ADDENDUM NO. 01

DATE 06.19.2014

PROJECT VMDO Project No.1115, Renovation of Three Residence Halls
PC# 217-17565-001

**PARTIAL FLOOR PLANS -
HVAC - POCAHONTAS**

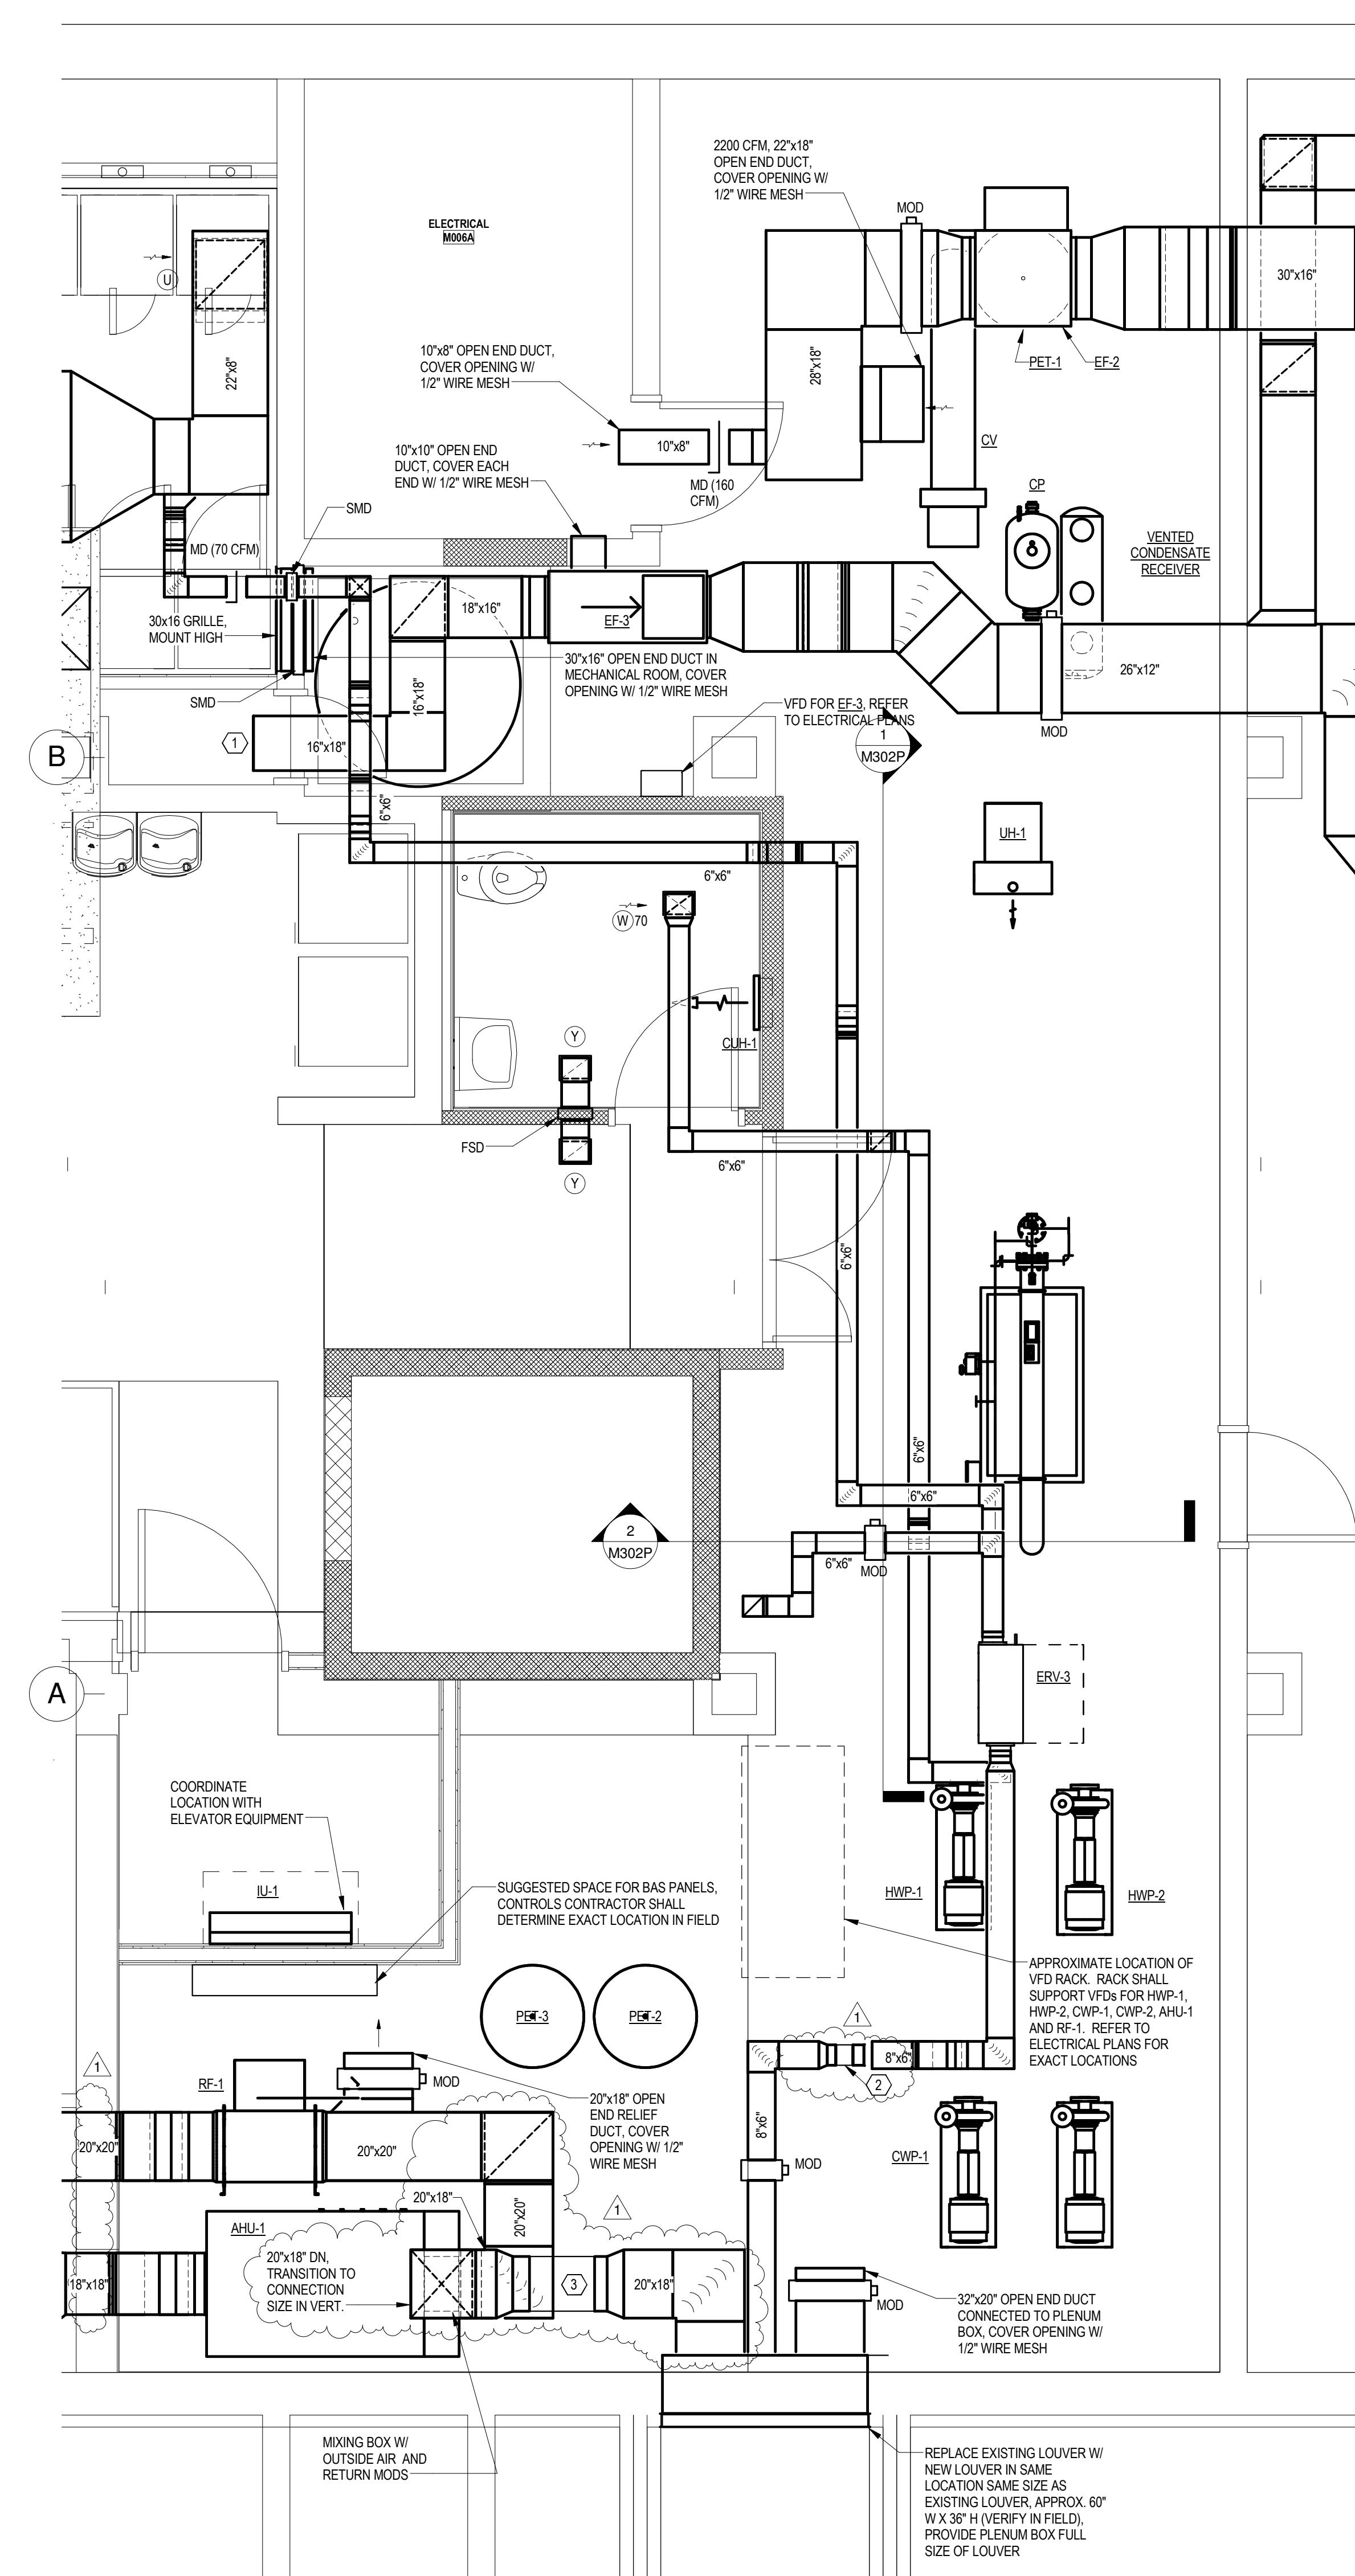
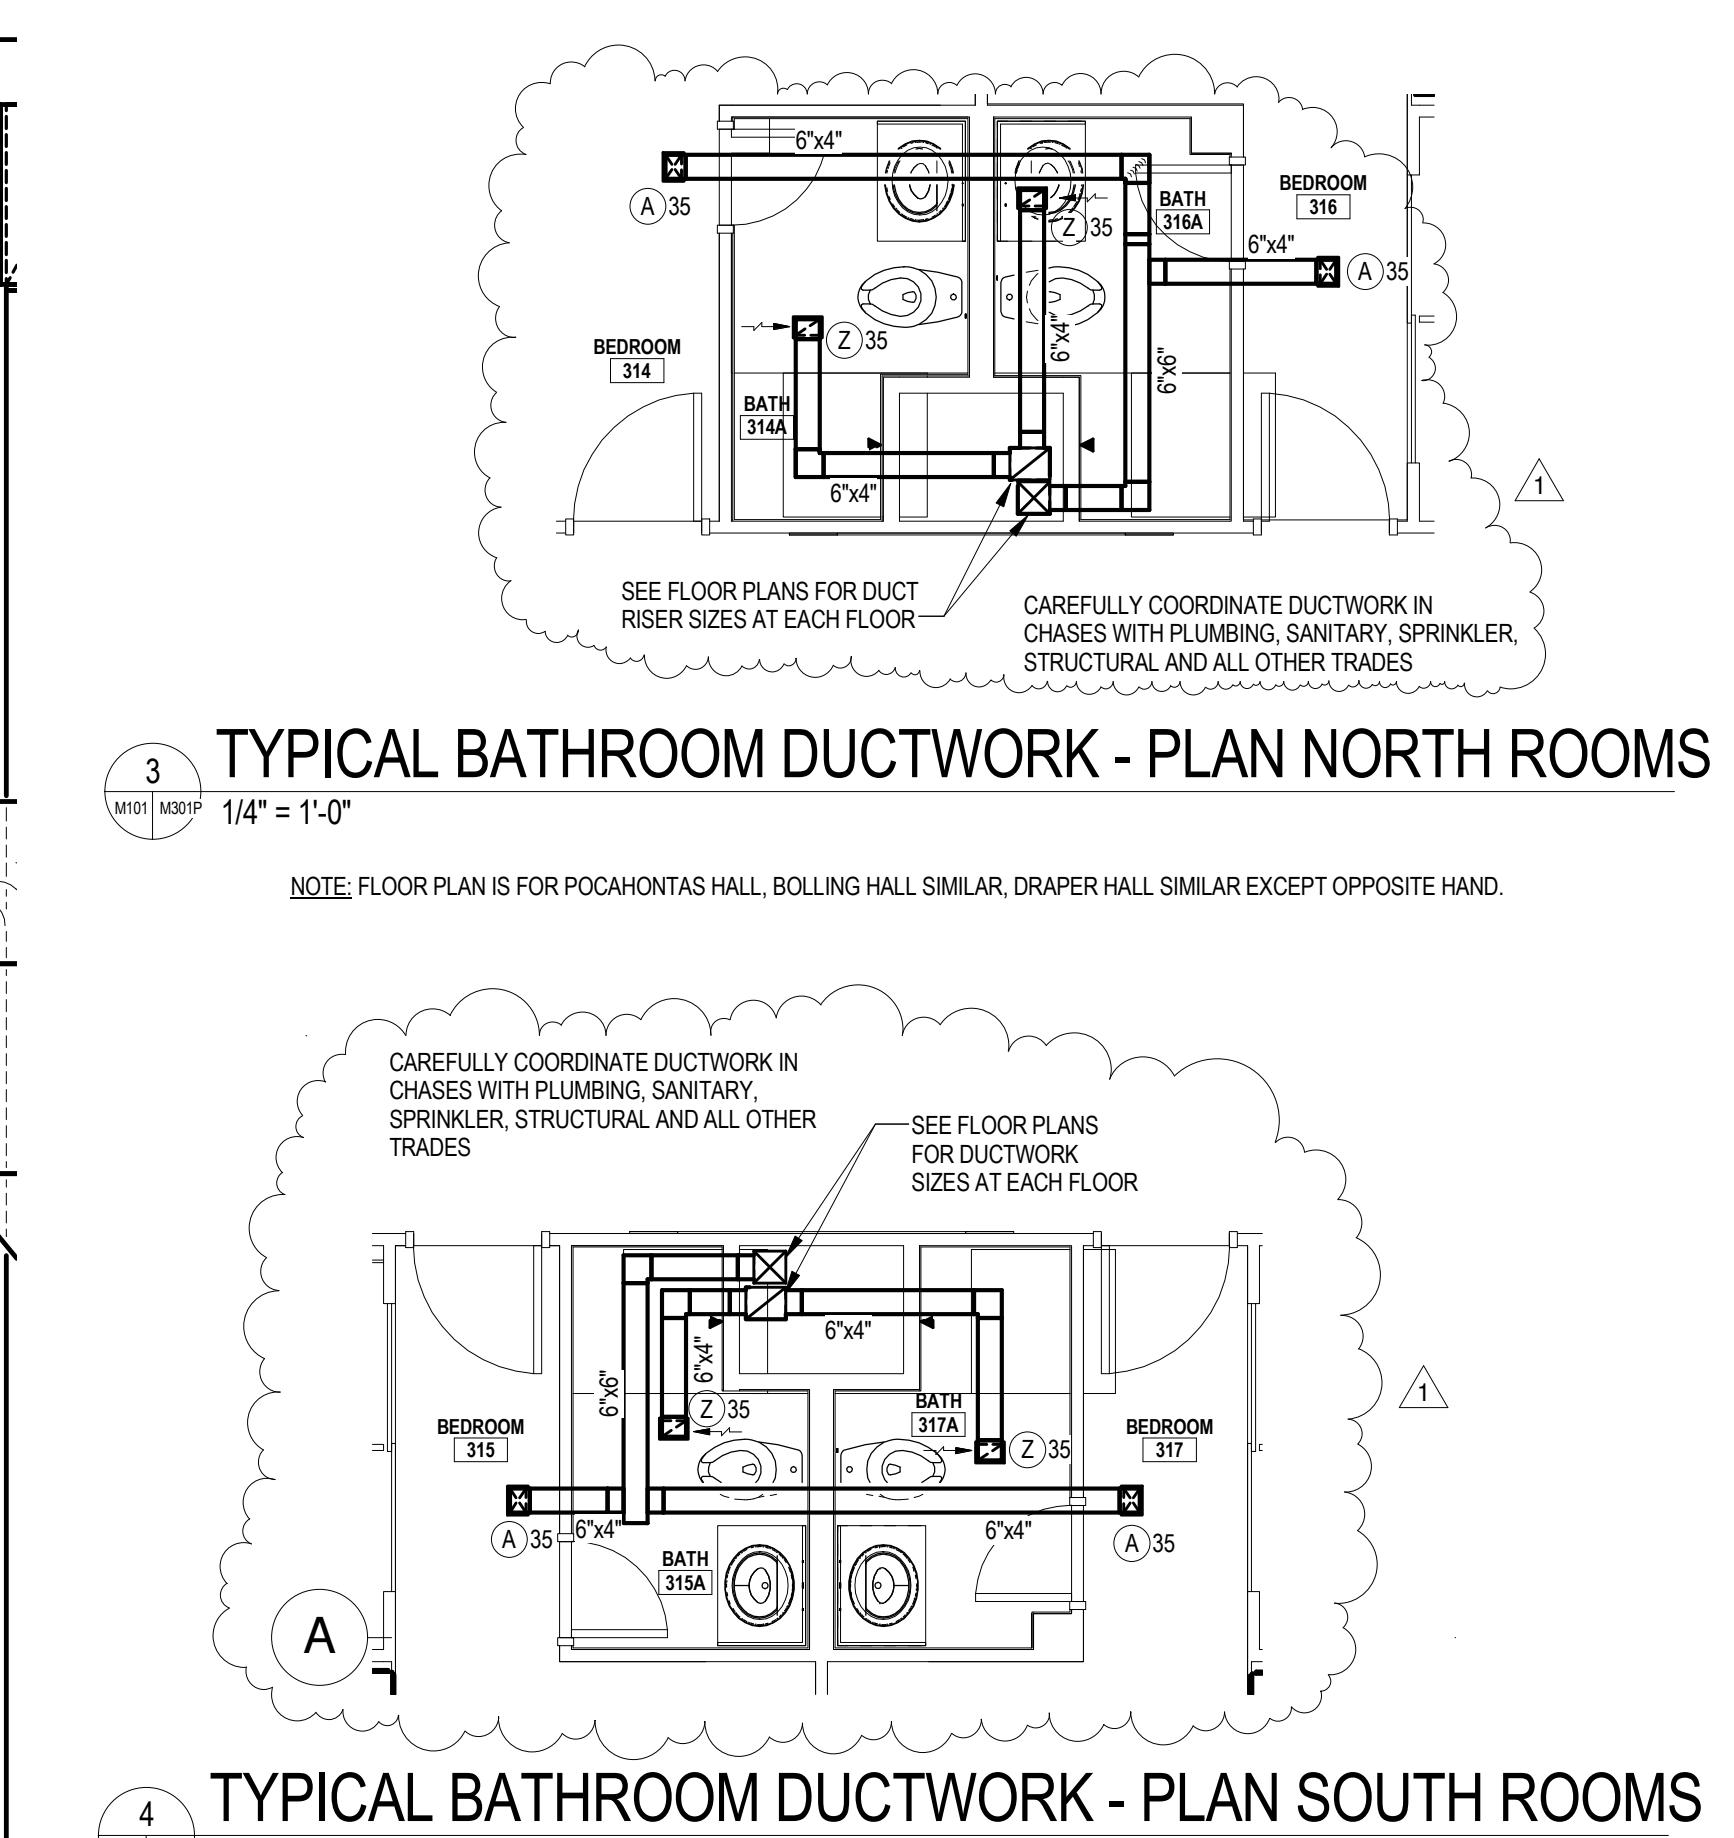
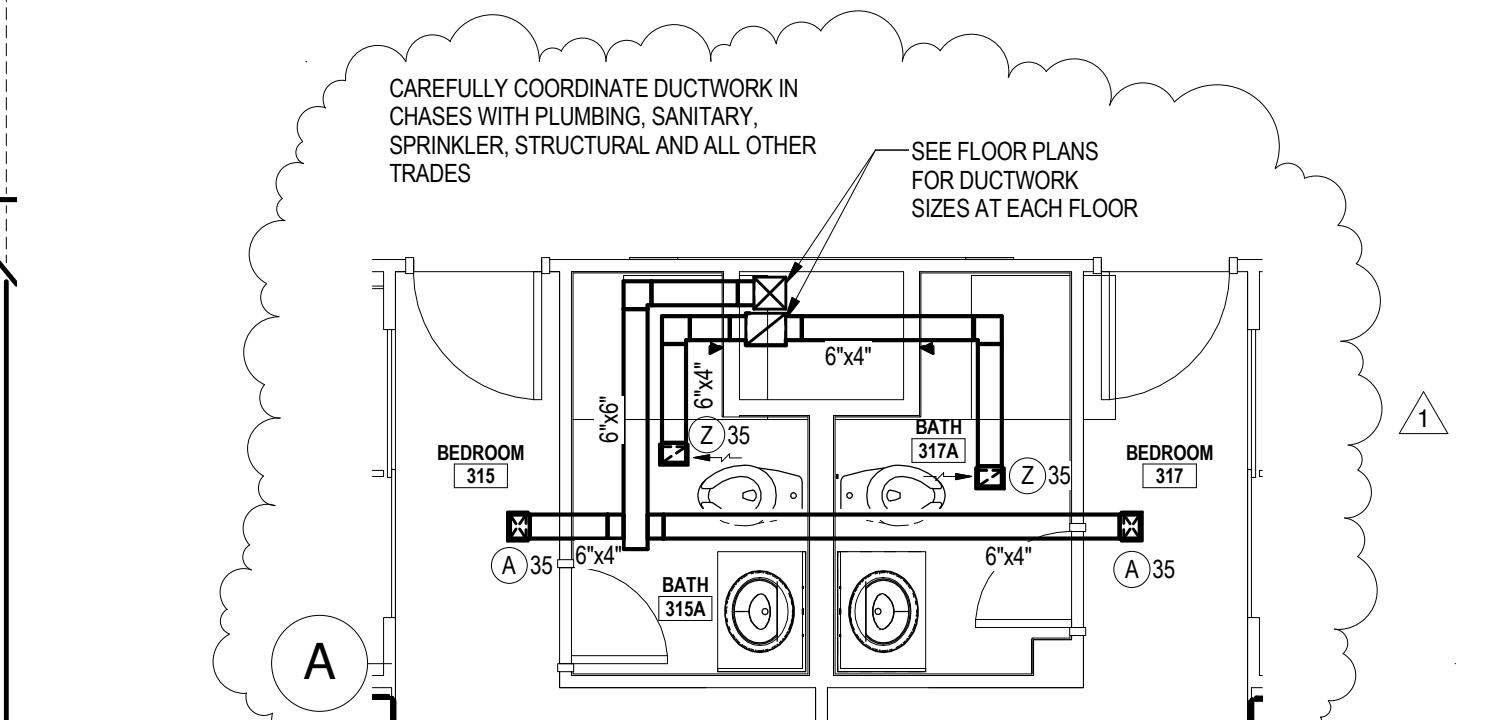
2.27 Remove fire dampers and add ductwork sizes to AHU-1 ductwork. Refer to attached revised drawing **M301P**.

2.28 Add airflow measuring station in AHU-1 outside air duct and modified duct routing. Refer to attached revised drawing M301P.

2.29 Add airflow measuring station in ERV-3 outside air ductwork. Refer to attached revised drawing **M301P**.

2.30 Modify ductwork routing in typical bathroom ductwork plans. Refer to attached revised drawing **M301P**.
